Staff Report

Subject: 225 Baltray Court

Subject: Request For Fence Placement Approval - 225 Baltray Ct.

Boundary and dimensions in red below

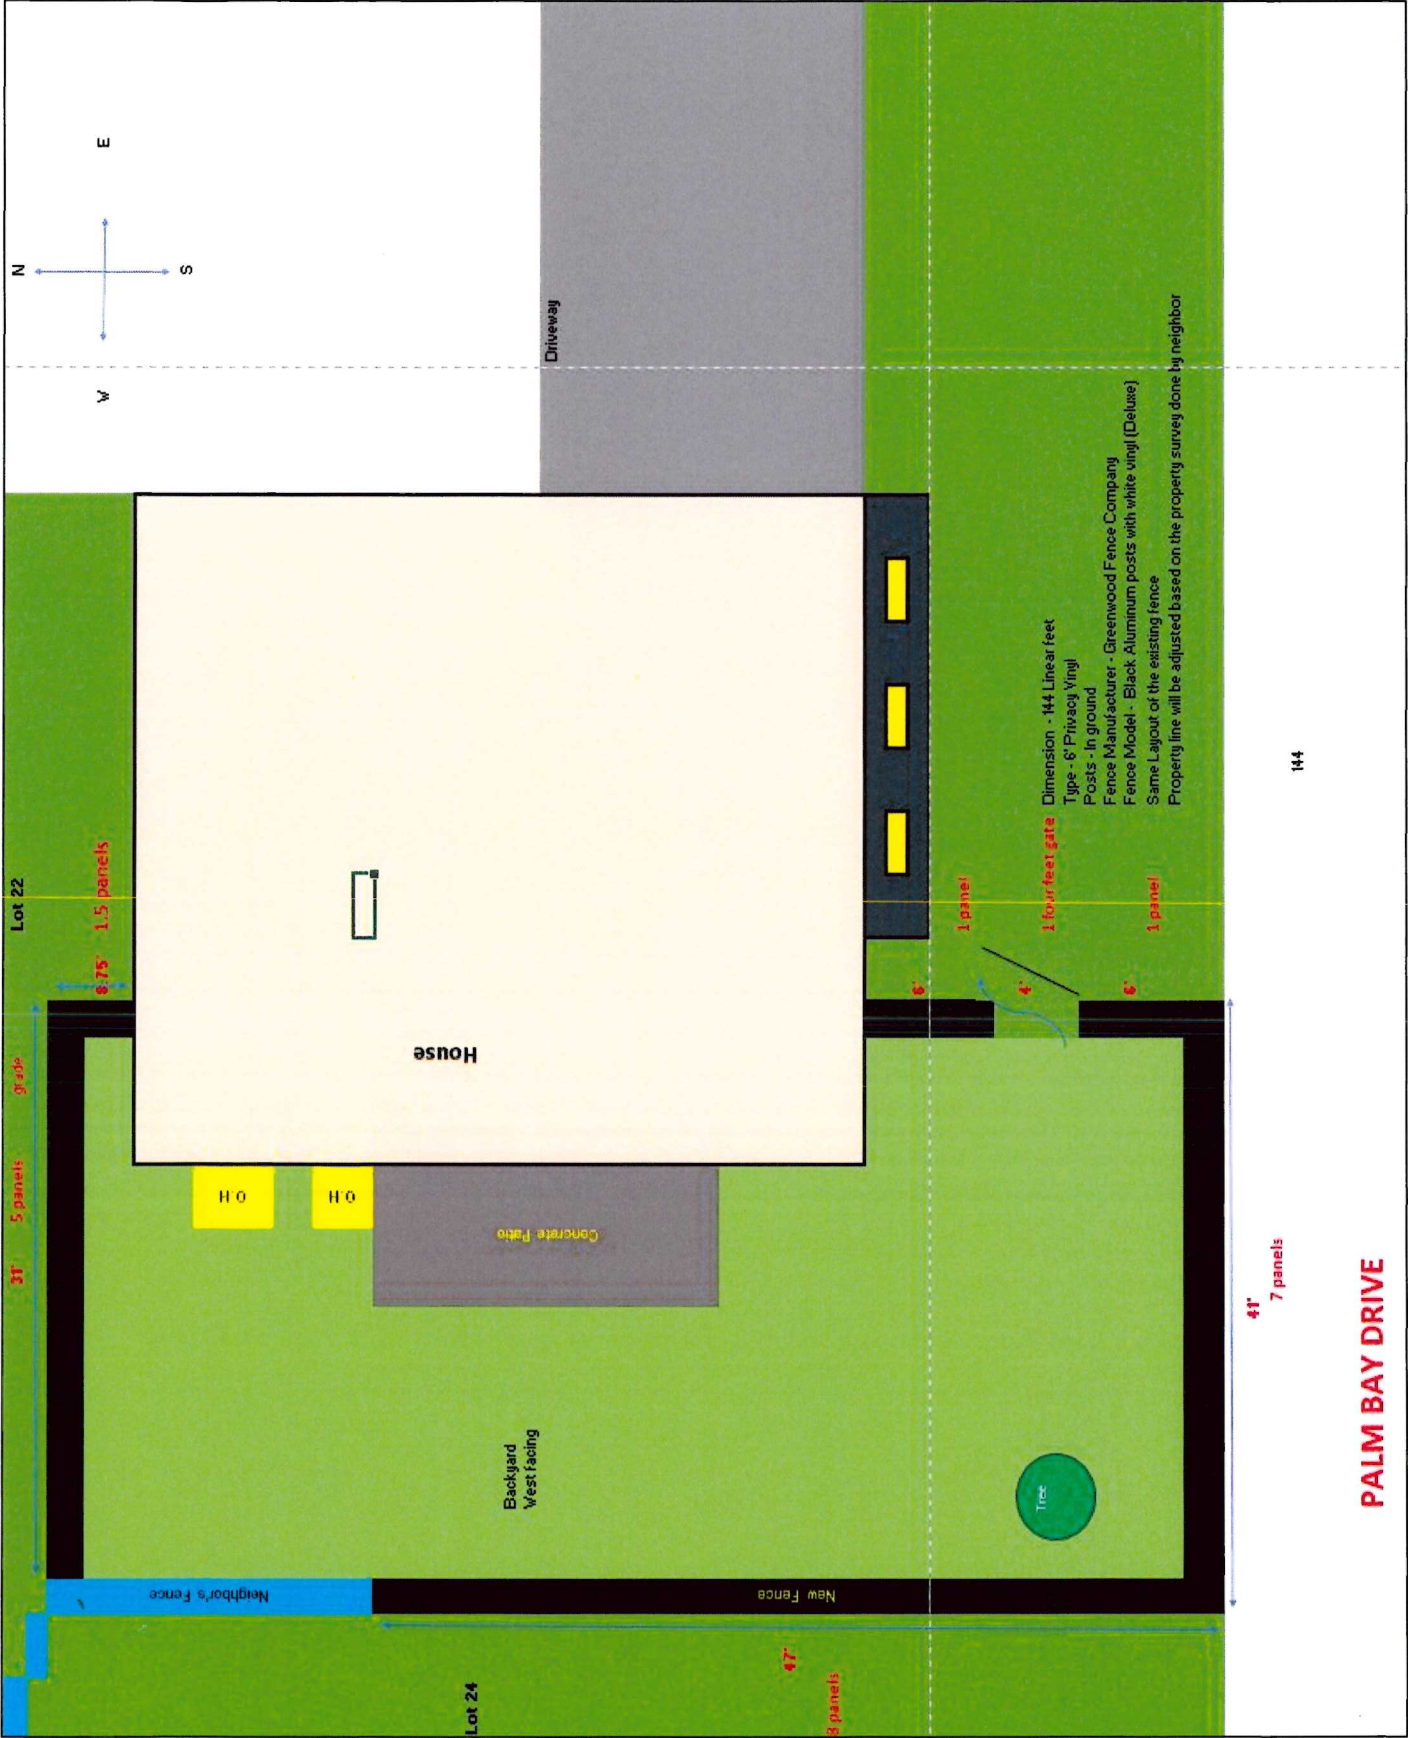
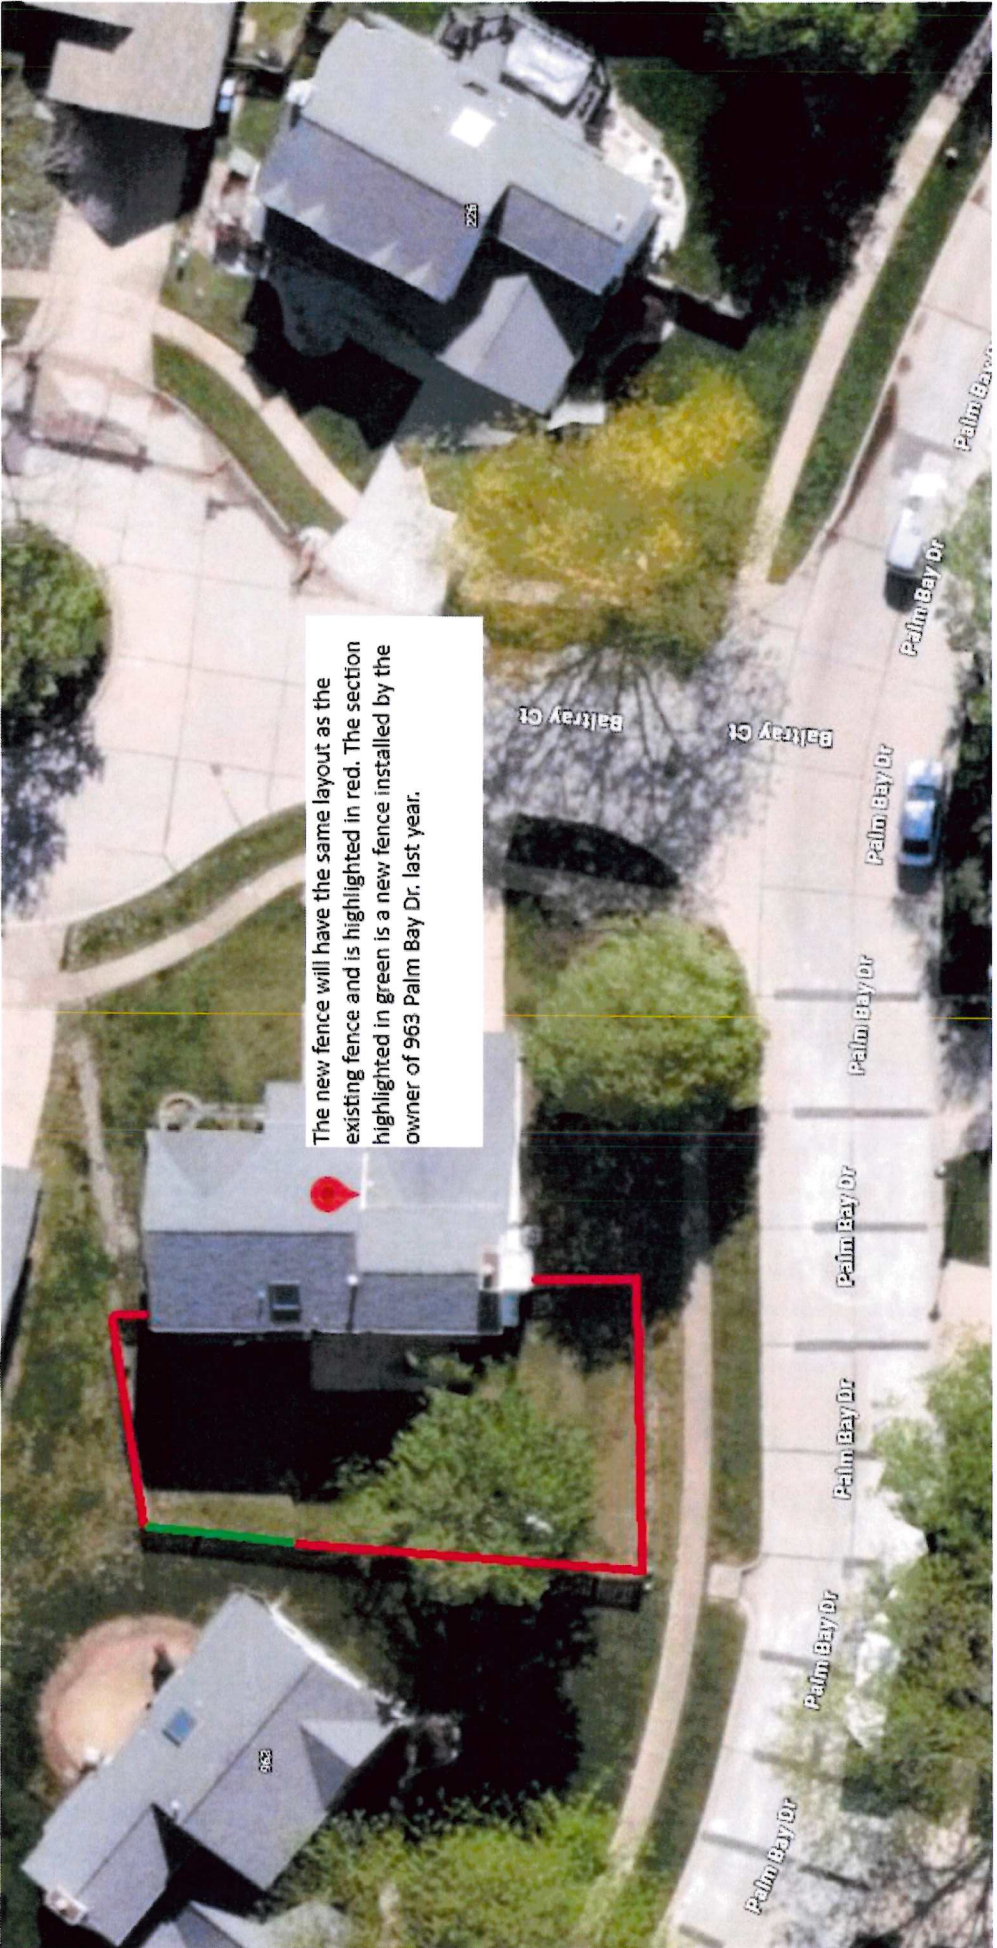
We have one question: will your new fence be attached to the fence at 963 Palm Bay Dr .? Or will your posts just butt to the adjacent owner's fence since it is of different construction?

Thank you for the clarification. Please consider this request approved.

The posts of our fence will butt against the posts of the adjacent neighbor's fence.

I see no way to attach fence panels to their posts even if they were of the same construction because there are no slots to allow for attachment.

The posts will be situated in such a way to minimize any gap and will not impact lawn care.
